Validation Report

VALIDATION OF THE CDM-PROJECT:
Ouro Small Hydropower Plant – Brennand CDM Project Activity

REPORT NO. 1225732

24 February 2011

Figure 1 –Exemplification of electricity generation and energy assured of a hydropower plant

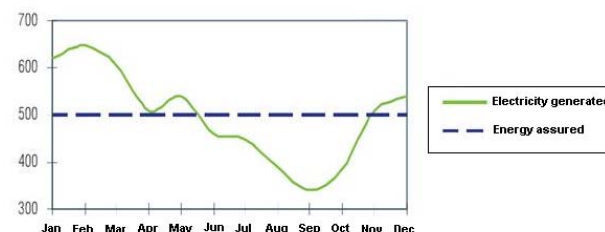
Continuation of CAR No. 12.

According to ANEEL explanations (<http://www.aneel.gov.br/arquivos/pdf/caderno3capa.pdf>): “...the energy assured is established independently of the real electricity generation; energy assured is associated to the estimated long-term operational conditions of power plants, assuming a specific risk of electricity supply (deficit) mainly when electricity generation is related to hydrologic variability whose hydropower plants are subjected to”.
